Product Change Notice

PCN#: EE-PCN22007

Eaton has improved the design construction of part number 0603ESDA-MLP7, Polymer ESD Suppressor. The improved package utilizes tin-plated via-less terminals instead of the gold-plated via terminals in the current design.

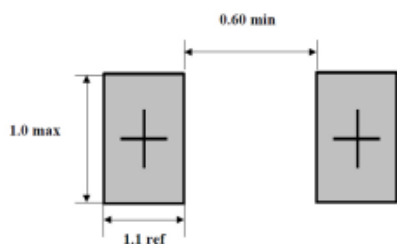
Eaton will offer two versions of the tin-plated via-less design. The 0603ESDA-MLP1 is the commercial grade version and the 0603ESDA-AEC1 is the automotive grade version. Both packages offer improved quality (solderability).

0603ESDA-MLP7 Pad Layout

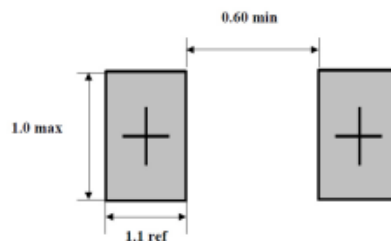
There will be no effect on the quality, reliability, or performance. There are no changes to form, fit, and function of the devices. This includes no changes to the pad layout.
